Item No. 45-16 Mr. Miller Date: 2/19/04

REVISION TO STANDARD DRAWINGS

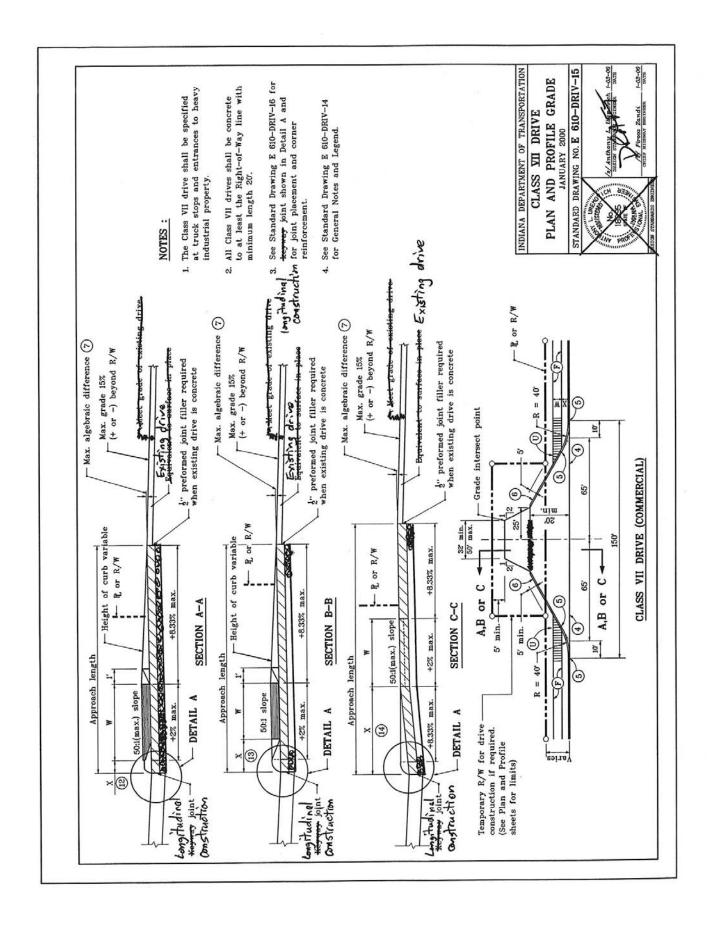
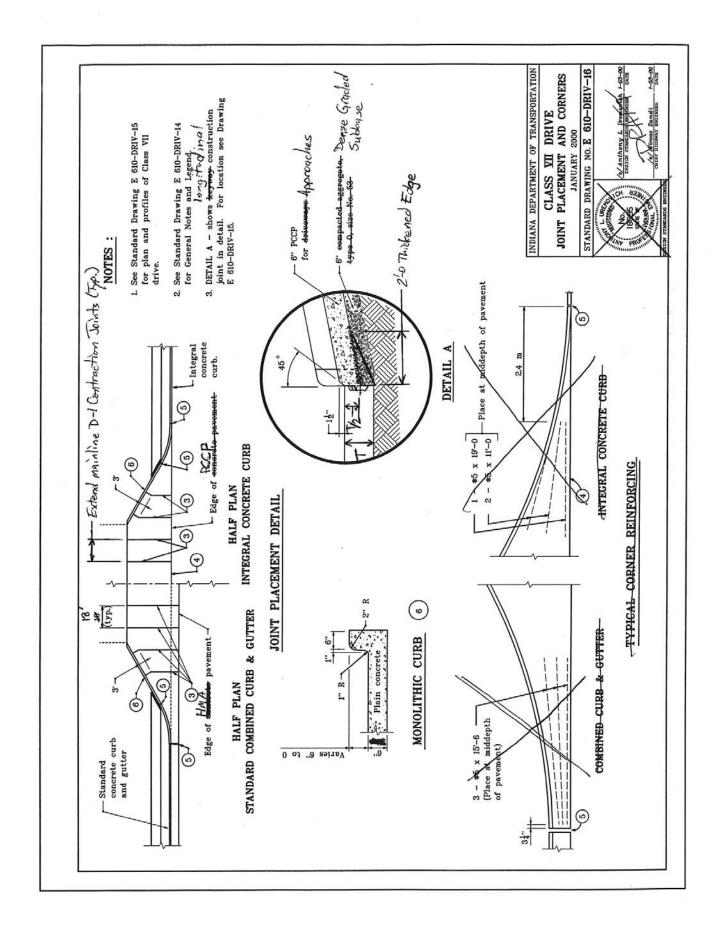
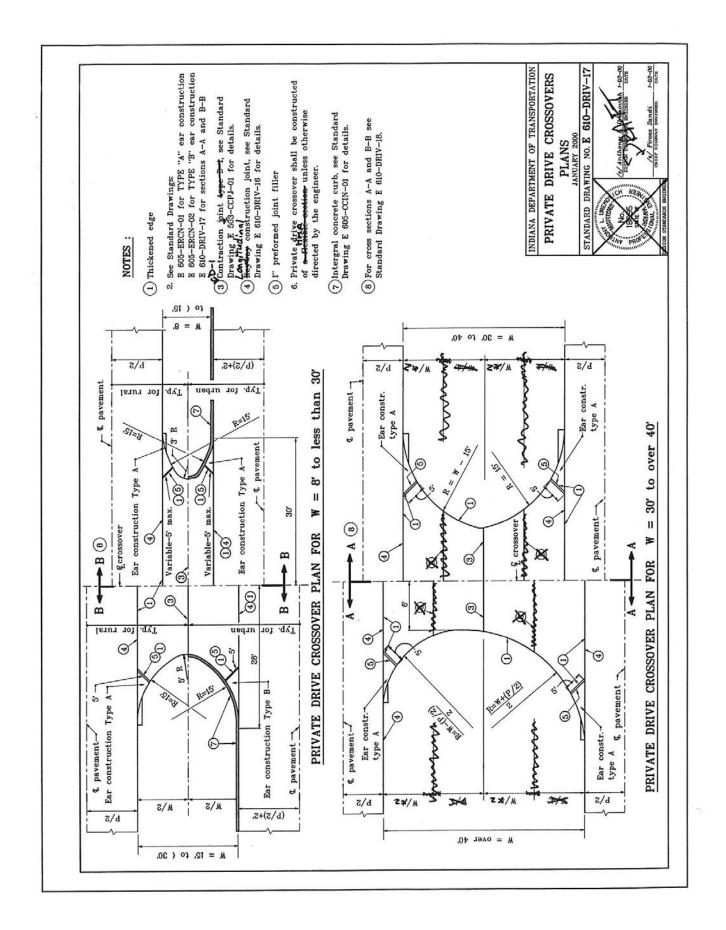
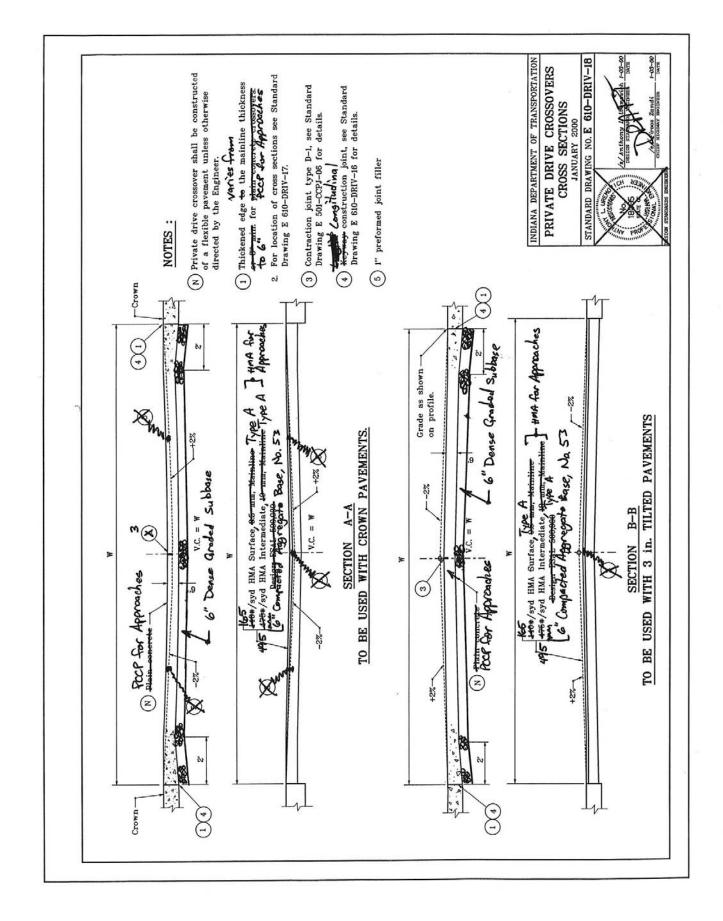
ian 200 per day, the required pavement section shall be as shown elsewhere on the plans.	ified as follows shall be: ctor. propriate end sections at when sidewalk is adjacent to curb. as shown on Standard	Hc - earth cover over culvert or pipe shall be 1 ft or greater. Curb ramp type G, as shown on Standard Drawing E 604-SWCR-09, shall be used when sidewalk is adjacent to curb. When X is equal to or greater than 2 ft but less than 5 ft, curb ramp type H as shown on Standard Drawing E 604-SWCR-09 shall be used. When X is equal to or greater than 5 ft, no curb ramp is required.
Driveway embankment slopes within the clear zone for a road functionally classified as follows shall be: 6:1 for an arterial or a high speed (over 40 mph design speed) collector. 4:1 for a local road or a low speed (40 mph or lower design speed) collector.	propriate end sections at when sidewalk is adjacent to curb.	toover over culvert or pipe shall be 1 ft or greater. type G, as shown on Standard Drawing E 604-SWCR-09, shall be used when si equal to or greater than 2 ft but less than 5 ft, curb ramp type H as show 604-SWCR-09 shall be used. equal to or greater than 5 ft, no curb ramp is required.

ine minimum diversity pavement section has been designed for contracts per day. In the truck trainic count is greater than 200 per day, the required pavement section shall be as shown elsewhere on the plans.	ified as follows shall be: ctor. propriete end sections at	
These notes are for Standard Braving E 610-DRIV-12, -13, -15, -16. The class VI and VII drives are designed to accomodate a WB-65 (IDV) design vehicle with a 45 ft turning radius. Crested The maximum algebraic difference in grades shall not exceed 8% for present grade nor 12% for expect grades.	day. If the truck traffic count is where on the plans.	The minimum driveway pavement section has been designed for 200 trucks per day. If the truck traffic count is greater than 200 per day, the required pavement section shall be as shown elsewhere on the plans. Driveway embankment slopes within the clear zone for a road functionally classified as follows shall be: 6: I for an arterial or a high speed (over 40 mph design speed) collector. 4: I for a local road or a low speed (40 mph or lower design speed) collector. Driveway culverts which cannot be located outside the clear zone shall have appropriate end sections at both ends.
